RF1 2

Project: COOLEY LABORATORY RENOVATION
Job: 3146 COOLEY LAB
Customer: STOFMT STATE OF MONTANA

Item: NEW METAL STAIR DETAILING
Reference: S2.4, 9/S3.1, 1/A8.2,

SKETCH 1

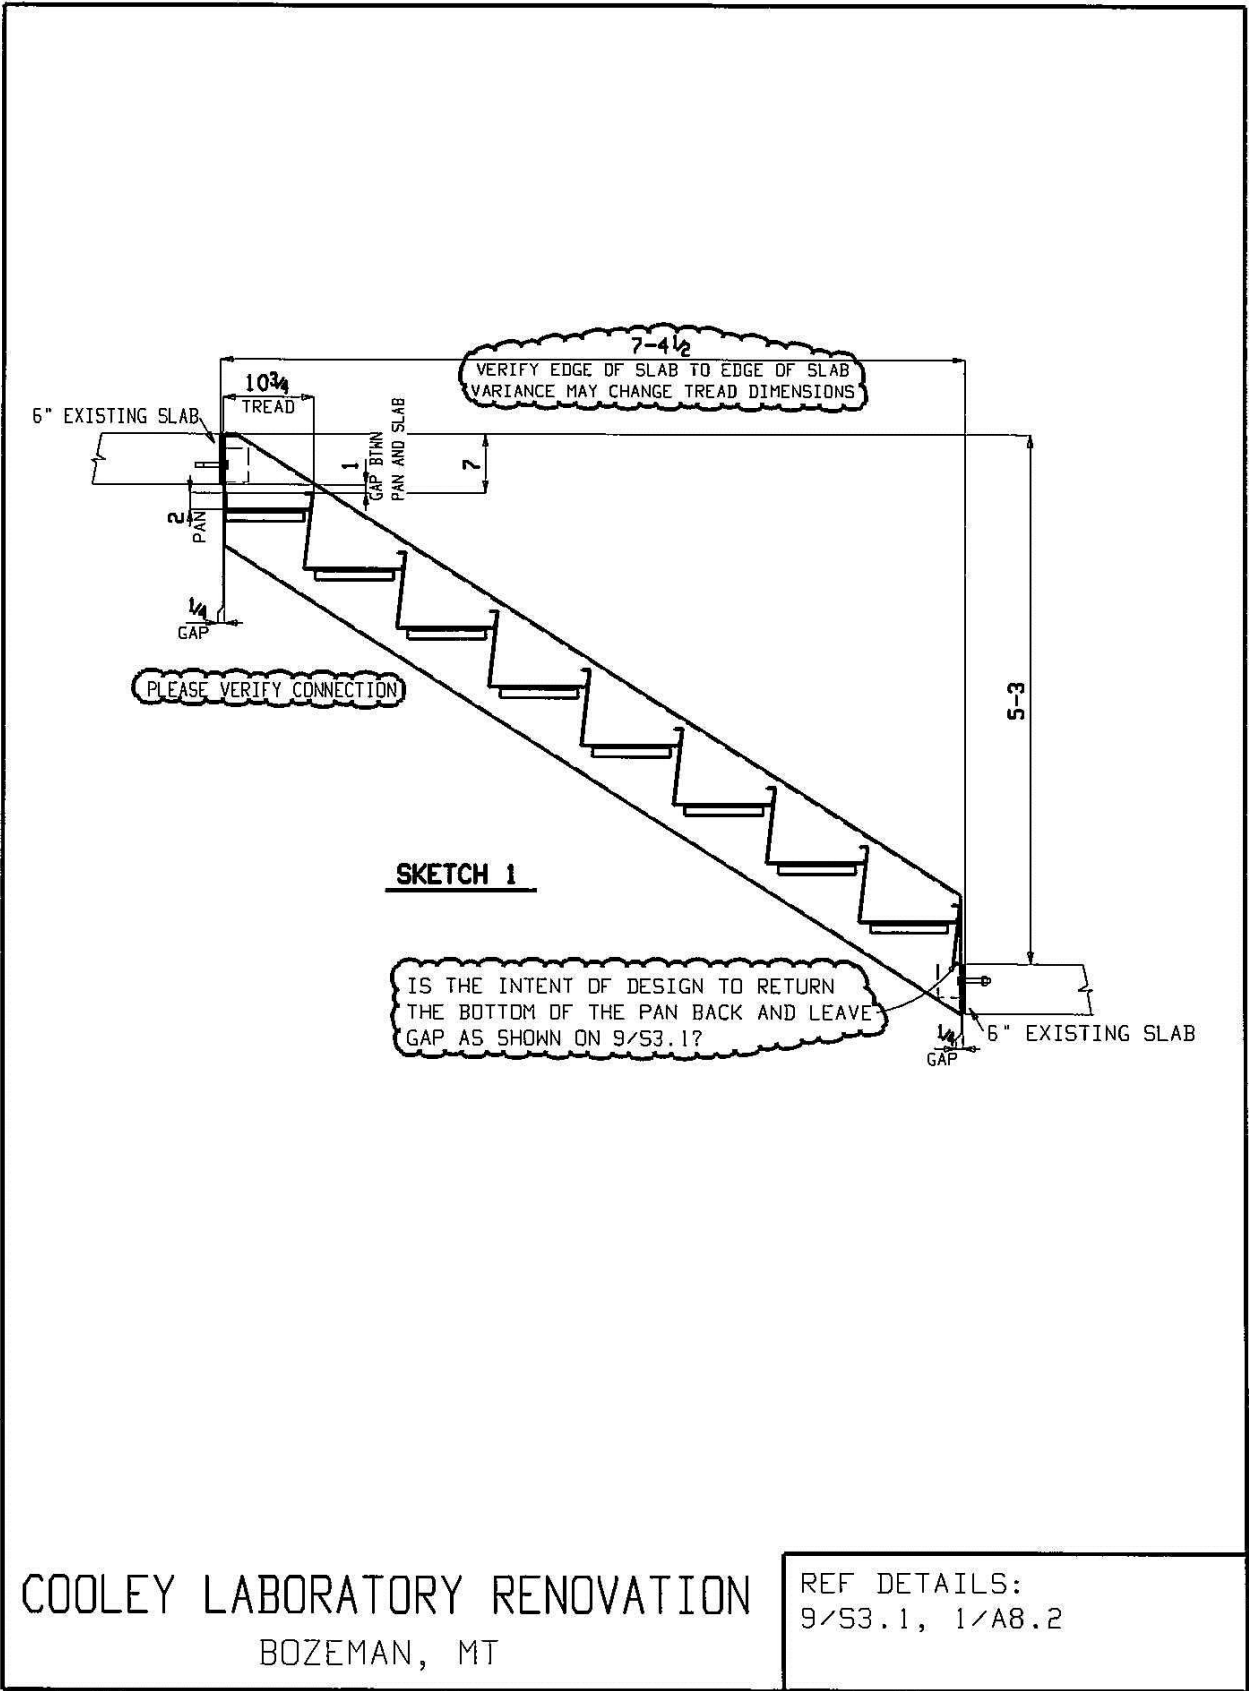
For proper detailing of the metal stairs leading from the 4th floor to penthouse. The steel detailer has requested the attached information.

Two clarifications we need before we can respond.

One, They are showing a stair run from existing slab to existing landing. We don't have that condition. We are going from the existing 4F to the existing roof slab and the intermediate landing is new.

Two. They are asking for us to confirm the horizontal run between the two "existing" slabs. See above. We would not verify a filed dimension. That is for the detailer and DA.
